Environment Agency Via Email Monday 8 July 2024

Ref: K6143/ENV/LT/02

Re: Middlemarsh Landfill Site Leachate Irrigation Scheme – K6143 Request for Further Information

Figure 1 – Example of Leaky Pipe Water Seepage and Drip Line Irrigation

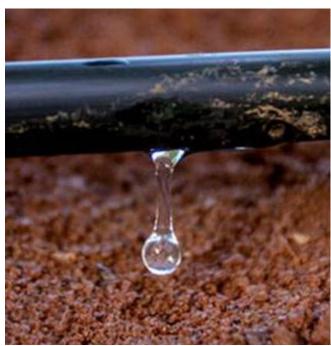
ii). Provide details on the technical design of the system and pipe spacing

Spray irrigation is to be carried out through a "leaky pipe" diffusion system which weeps a small quantity of irrigant from a porous pipe directly above the soil surface, and thereby reduces the potential for moisture loss through direct irrigation. Alternatively, a dripline system of similar capability but dripping irrigant at c.33 cm spacings. These type of systems are intended to negate direct volatilisation as a small volumetric rate seepage that does not actively cause volatilisation as a spray irrigation system would.

A network of irrigation pipework¹ which is rated as having approximately a 2l/hr irrigation rating will be placed within the proposed area of irrigation. The pipe work will be laid directly onto the ground surface on a nominal minimum 5m spacing within the 2.3ha central area of the site to be irrigated.
